# Rosefield Solar Farm

## Consultation Report

### Appendices K-1 to K-4

EN010158/APP/5.2  
September 2025  
Rosefield Energyfarm Limited

DRAWING TITLE:  
**Proposed increases to the proposed Rosefield Solar Farm Site Boundary ("the Order Limits")**

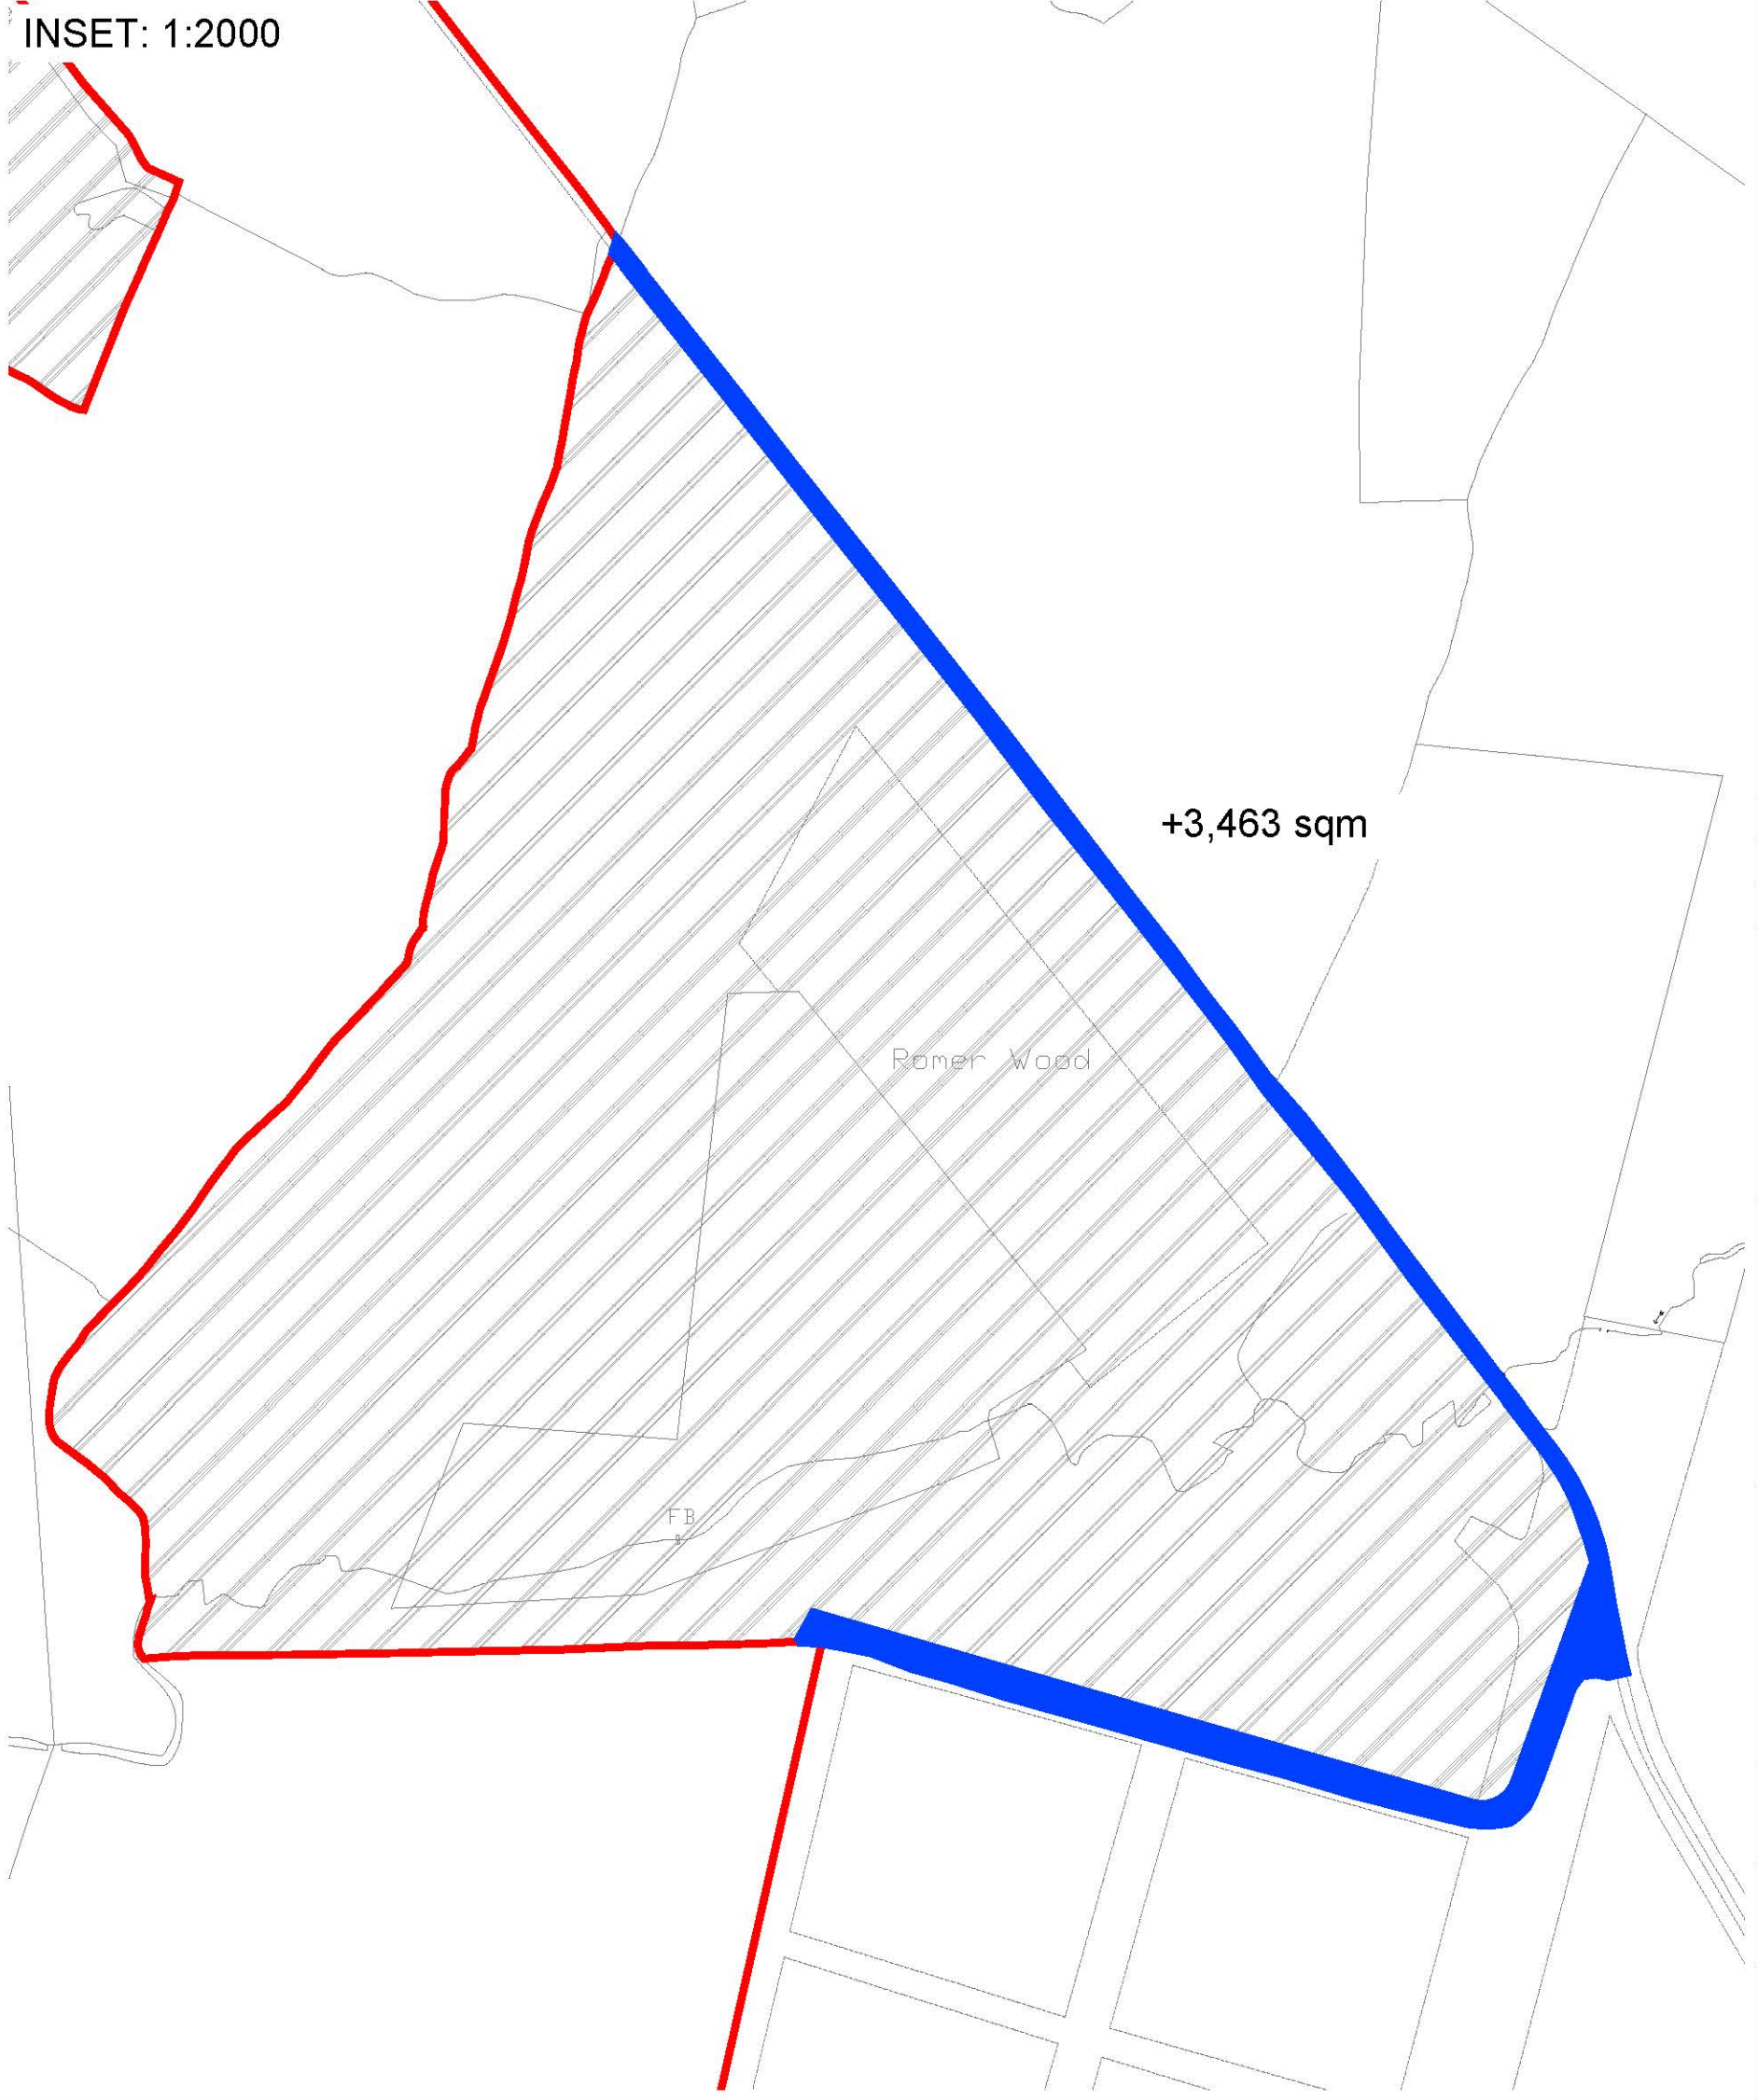
The enclosed plan shows the full extent of the Order limits of the proposed Rosefield Solar Farm (outlined in red), with the proposed additional land shown in blue.

To access areas proposed for landscaping and environmental enhancements in Parcel 1a (see enclosed plan), we have identified an existing track currently used by traffic associated with HS2 for the same purpose (planting and maintenance of landscaping). We are proposing to incorporate this track into the Order Limits for the lifetime of the Proposed Development. This would allow light vehicles, such as tractors, to access this area for planting and maintenance.

TITLE:  
COMPARISON OF PHASE 2 AND PHASE 3  
ZONAL MASTERPLANS (PARCEL 3)

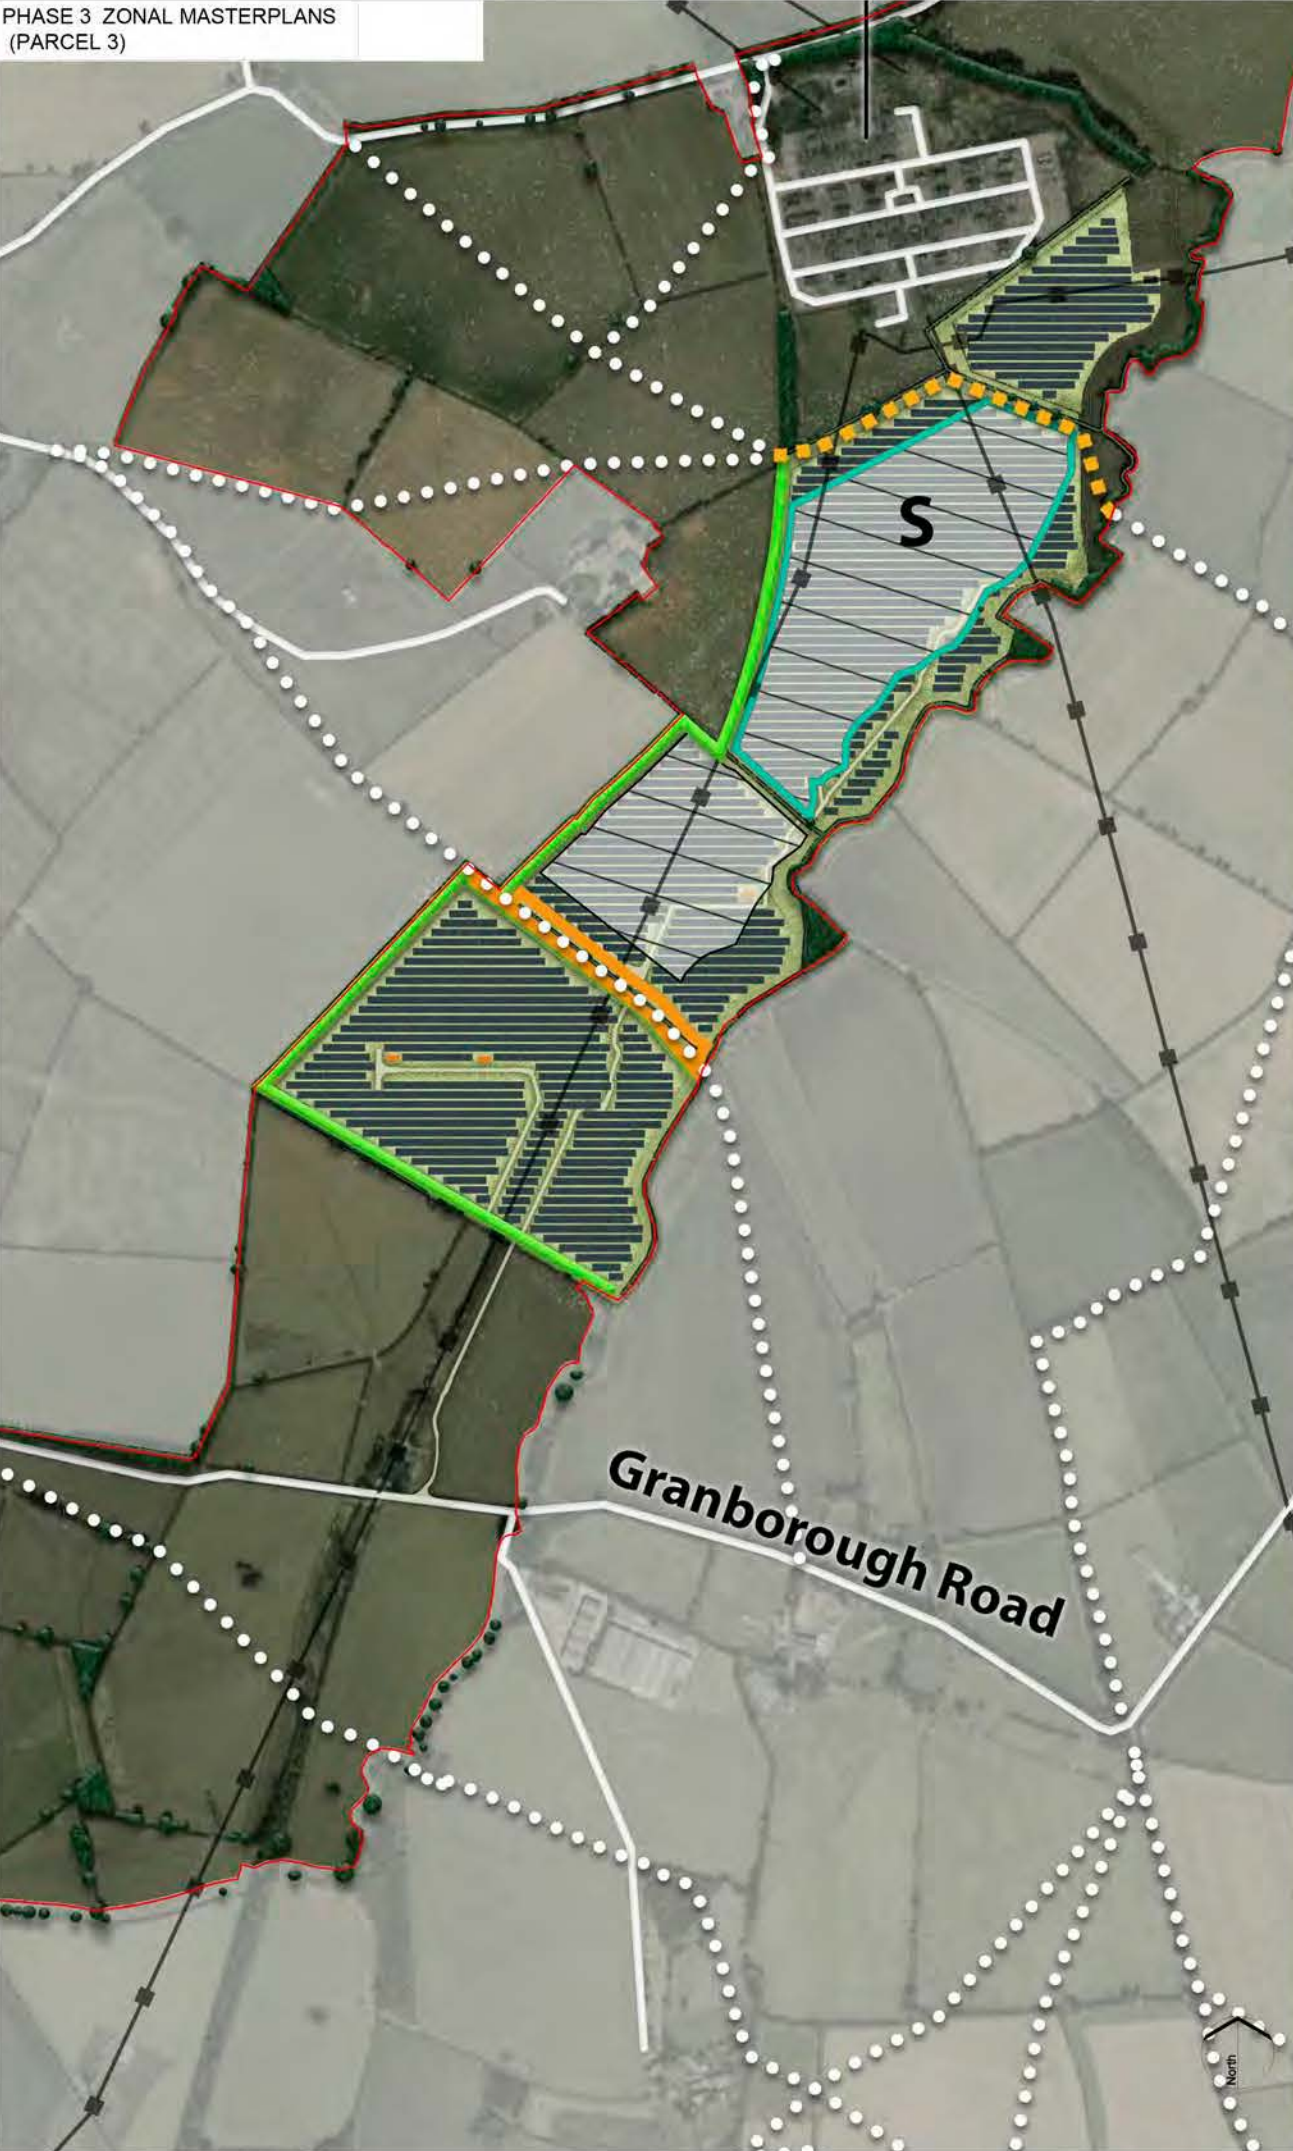
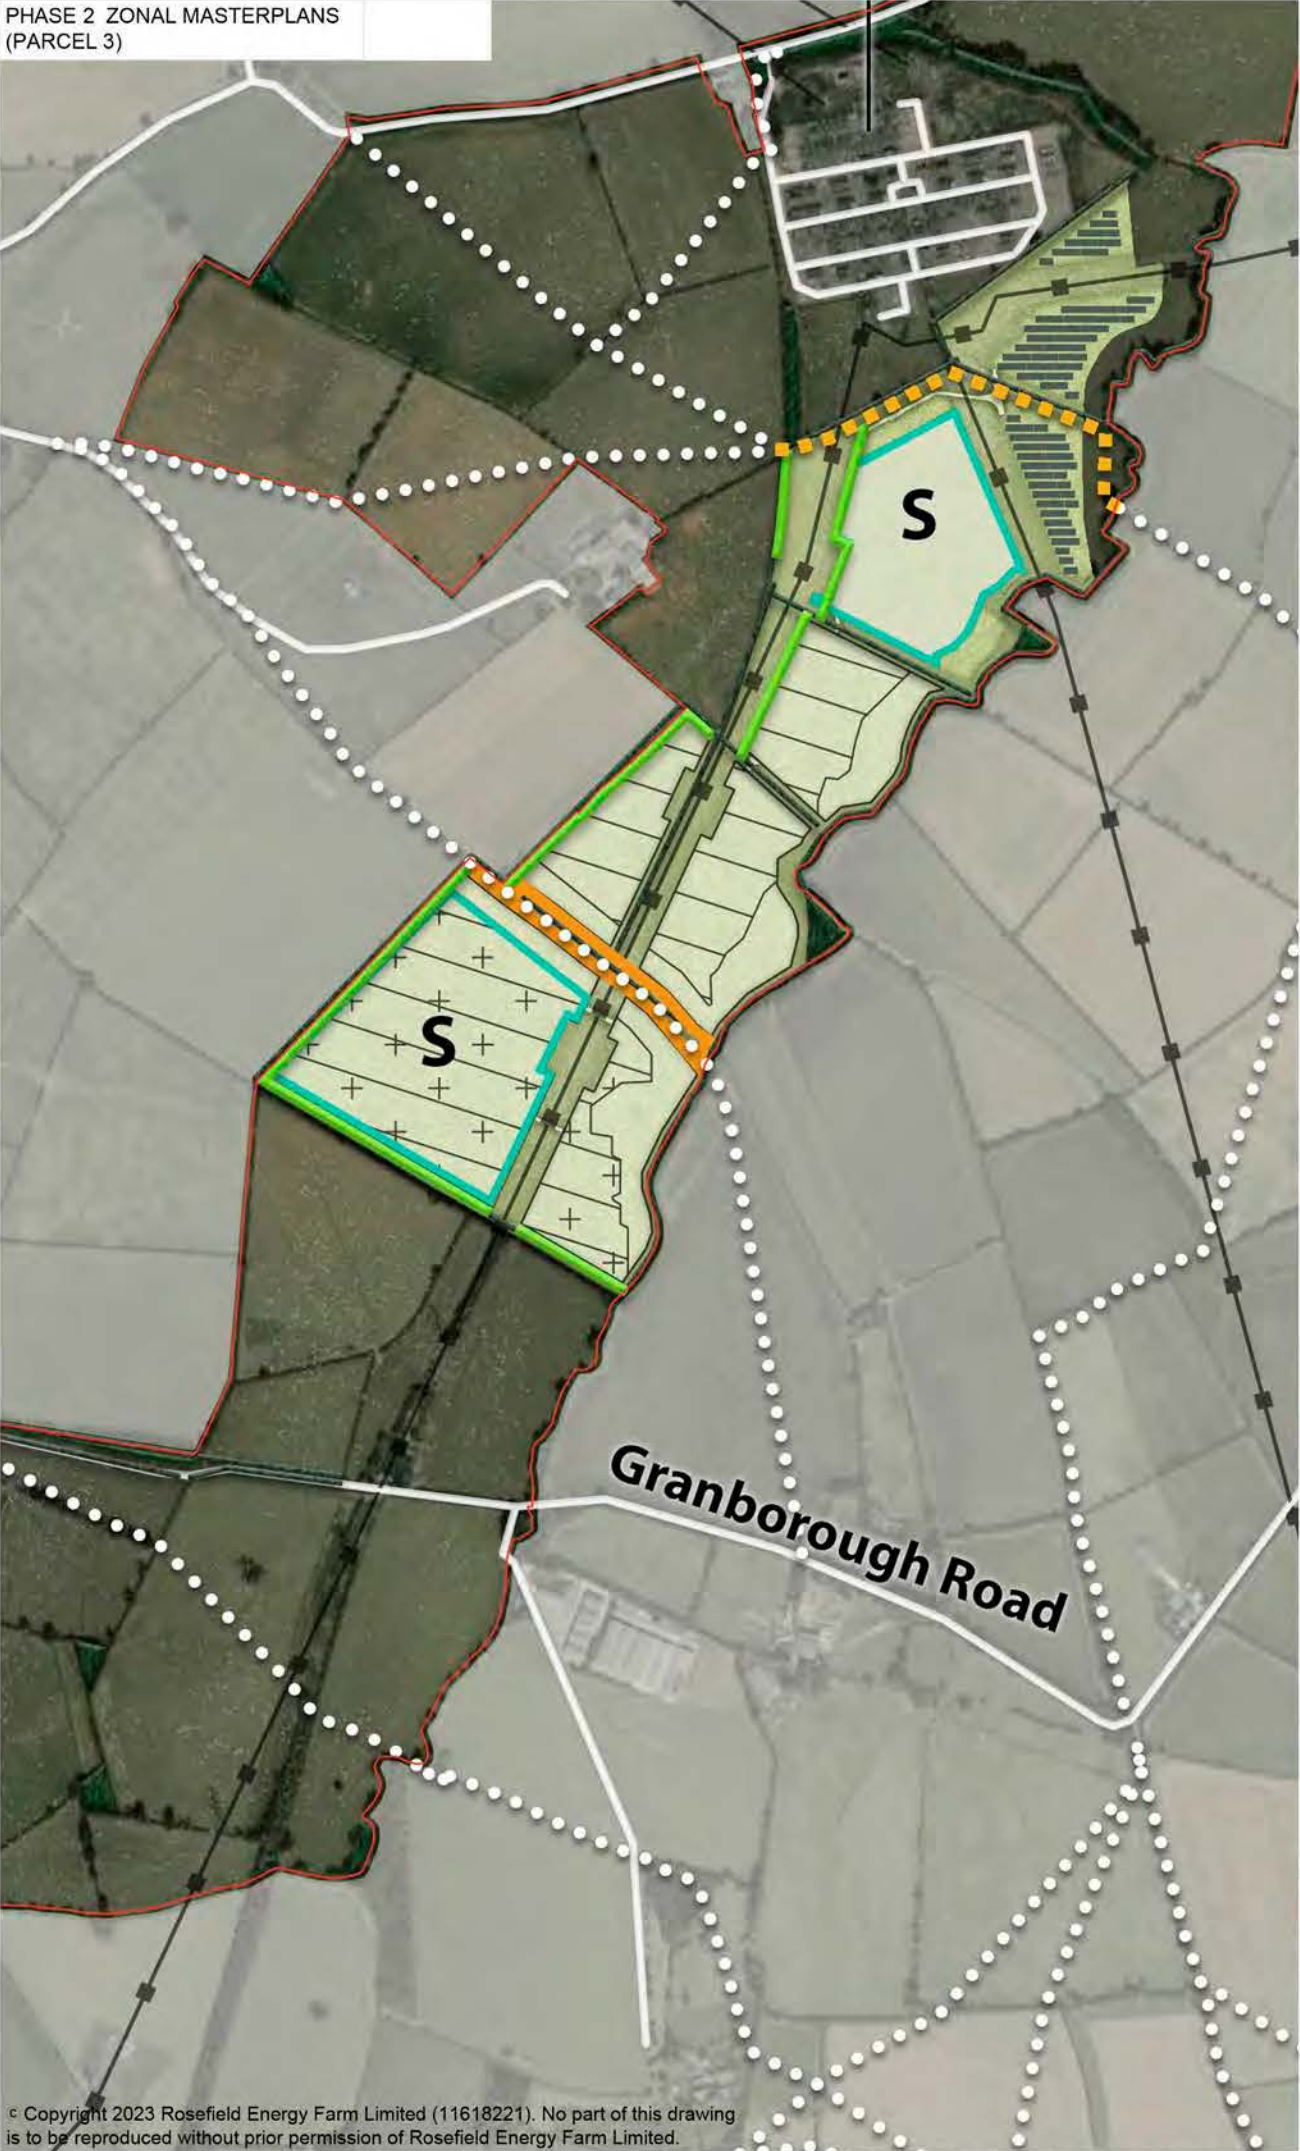
**Proposed change:** Feedback from Phase Two Consultation has enabled us to discount Scenario Two. We are now proposing to locate the Rosefield Substation and Main Collector Compound closer to the replacement National Grid East Claydon Substation in line with Scenario One. The potential siting area for these elements shown in Scenario One has been extended to the southeast into Field E20, acknowledging that the exact location of the replacement National Grid East Claydon Substation has not yet been confirmed.

**Proposed change:** We are no longer proposing to locate battery storage within the eastern area of the site, in response to feedback received to Phase Two Consultation. This means that battery storage is now only proposed to be located in one zone within the central part of the site in Fields D8/D9, next to Claydon Road.

The enclosed plan shows our updated layout within the eastern part of Rosefield Solar Farm, with an extract of the previous proposed layout in this area for comparison.

- At Phase Two Consultation, the BESS was proposed to be in Field E23 in Parcel 3 and/or Fields D8/D9 in Parcel 2. In response to feedback received, Field E23 has been removed as an option for the BESS site. The BESS is now solely proposed to be located in Fields D8/D9 in Parcel 2.

- At Phase Two Consultation, the Main Collector Compound was proposed to be located in either Field E20, E21, E22 or E23 in Parcel 3. In response to feedback, Field E23 has now been discounted as a potential location, while Field E11 is being considered alongside Fields E20, E21 or E22 in Parcel 3.

- 2.1.2. As a result of the changes detailed above, there would also be a potential requirement to remove a maximum of 210m of hedgerow boundary between Fields E11 and E20 in Parcel 3 to accommodate the Rosefield Substation.
